Master Plan Amendment #2020-00002
Rezoning #2020-00001
Development Special Use Permit #2019-00028
Transportation Management Plan SUP#2020-00009
701 North Henry Street

Application	General Data	
Project Name: 701 North Henry Street	PC Hearing:	June 25, 2020
	CC Hearing:	July 7, 2020
	If approved, DSUP Expiration:	July 7, 2023
	Plan Acreage:	
Location: 701 North Henry Street	Current Zone:	CSL/Commercial Service Low
	Proposed Zone	CRMU-M/Commercial Residential Mixed Use (Medium)
	Proposed Use:	Multi-Family Residential with Retail
	Dwelling Units:	94
	Gross Floor Area:	95,995 SF (residential & retail) 138,820 SF (w/ parking garage)
Applicant: Avanti HG 701 LLC., represented by M. Catherine Puskar, Attorney	Small Area Plan:	Braddock Metro Neighborhood Plan
	Historic District:	N/A
	Green Building:	Compliance with City's 2009 Green Building Policy

Purpose of Application
Consideration of a request to demolish an existing commercial business and warehouse to construct a 94-unit multi-family residential building with underground parking and ground floor retail ready space.
Special Use Permits and Modifications Requested:
<ol style="list-style-type: none"> 1. Master Plan Amendment to amend t

Exhibit A – Applicant’s exterior revisions presented at the June 25, 2020 Planning Commission meeting

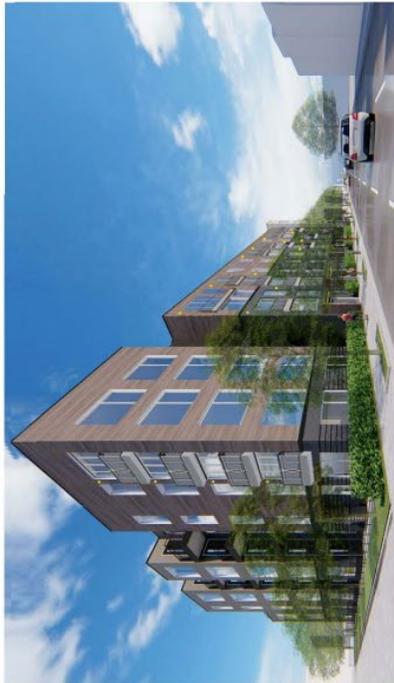
Ms. Puskar requested that the proposed revisions to the building exterior as shown in her presentation be included with the approval of the project, by amending Condition #1 to reference the exhibit shown. She also clarified that she spoke to Ms. Courtney and that streetscape was designed as proposed to reflect the pattern of the neighborhood, but that the applicant could go either way on providing more greenspace.

The Final Site Plan shall be in substantial conformance with the preliminary plan dated March 23, 2020 and the exhibit shown by the applicant at the June 25, 2020 Planning Commission meeting, and comply with the following conditions of approval. (PC)

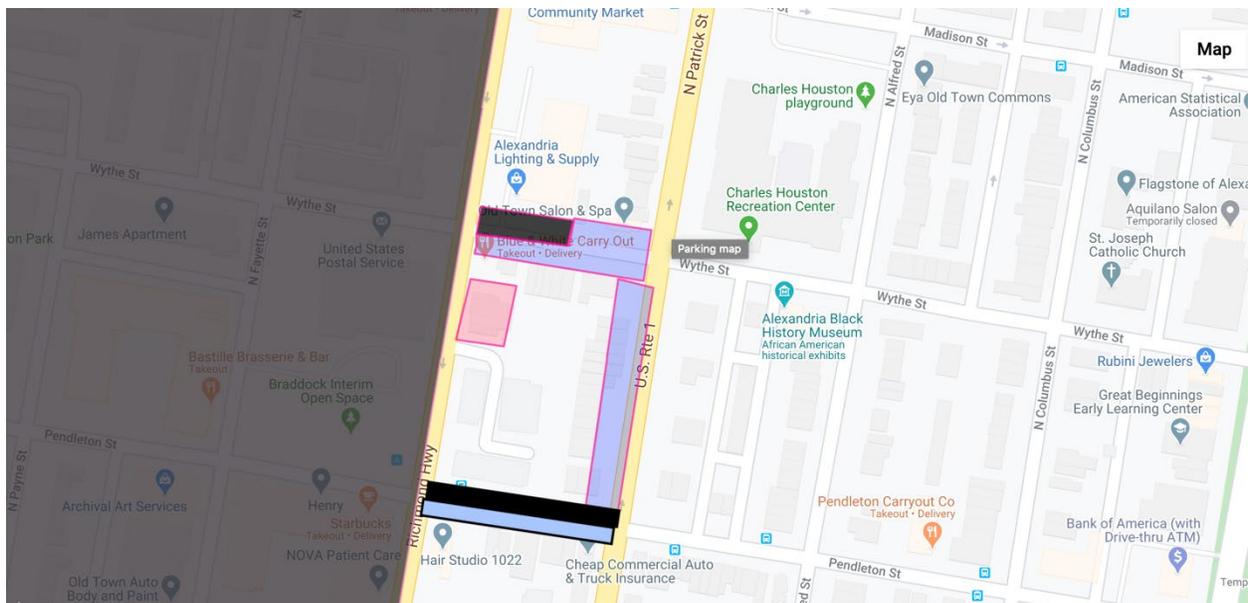
Hello. I wanted to draw attention to the parking situation around the 600 block of North Henry St. There are 11 street facing homes on the road 600 block of North Henry St, 5 of which have no off-street parking.

Due to the fact that we are residents in parking district 3 and Henry St is only for those in parking district 5, we have no choice but to park on the 1000 blocks of Wythe St and Pendleton St.

1/4 of the 1000 block of Wythe St is blocked for parking by the driveway to 701 N Henry St. The remainder is marked as 2 hour non-residential.

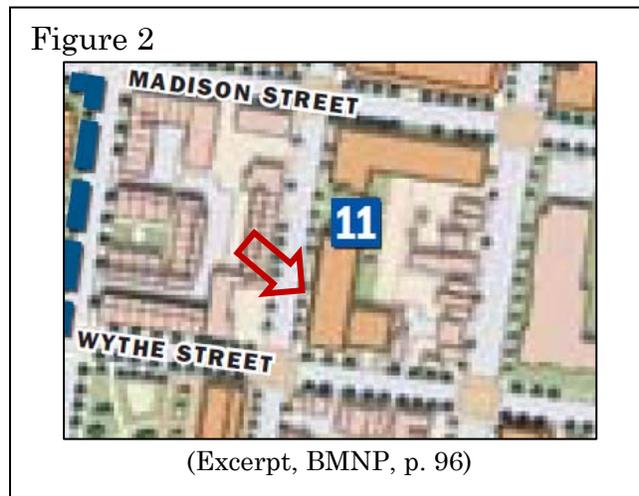
The applicant’s proposed heights and setbacks are inconsistent with the Small Area Plan. As shown in Figure 1, the Braddock Metro Neighborhood Plan (BMNP) limits the height of this site to 30’ for the eastern half of the site except a 40’ portion adjacent to Wythe—consistent with adjoining Parker-

Gray homes that are two stories tall. The BMNP permits 50’ only directly along Henry Street. In other words, as shown in Figure 2, the BMNP provided for an L-shaped building that provides appropriate setbacks and transitions from the adjoining two-story historic homes. The applicant’s five-story C-shaped proposal is inconsistent with the BMNP, exceeding the “maximum height[s]” of 30’ and 40’ for most of the site that are necessary to “ensure transitions in scale between the two and three-story fabric” of the adjoining homes.¹

Figure 6

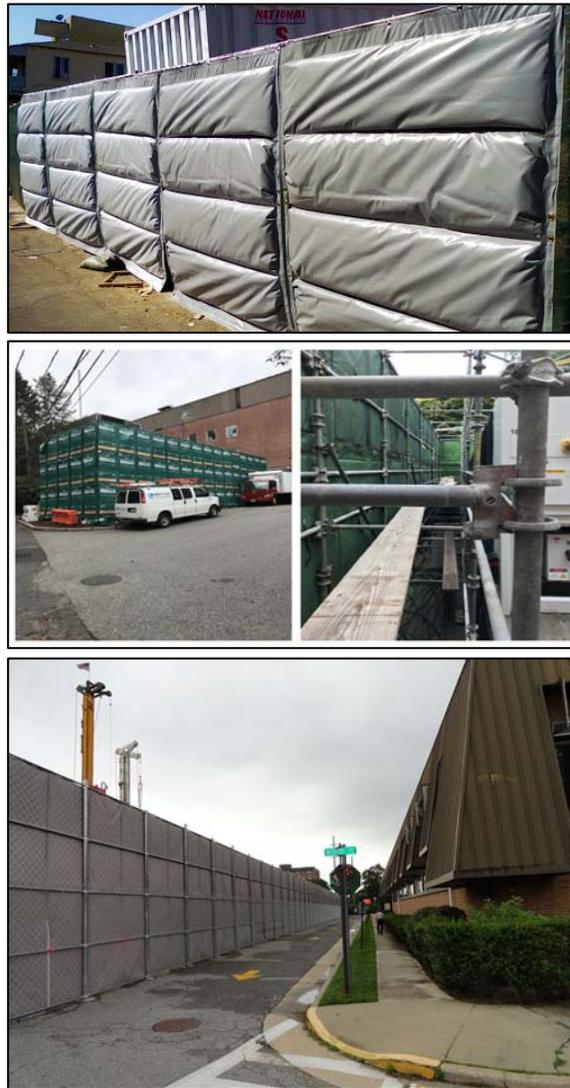
Second, contrary to the applicant’s claim to us that temporary noise barriers were not viable, we know that such barriers exist as we have seen them widely used for construction in residential areas. A quick Google search reveals a plethora of temporary construction noise barriers that provide “an economical and effective method of reducing noise generated by equipment, pumps, generators or other processes and are exposed to the elements,” and common applications for these barriers specifically include “Any type of building construction in a residential area.”¹³ Various types of “temporary noise control barriers are used across the nation and worldwide, eliminating nuisance by reducing noise pollution by up to 97%.”¹⁴ These barriers should be used here to reduce the noise pollution emanating from the applicant’s proposed construction site.

Third, given the applicant’s surprising unfamiliarity with noise mitigation issues, it seems clear that consultation with noise mitigation professionals (acoustic engineers) would be appropriate. It is difficult for us, as
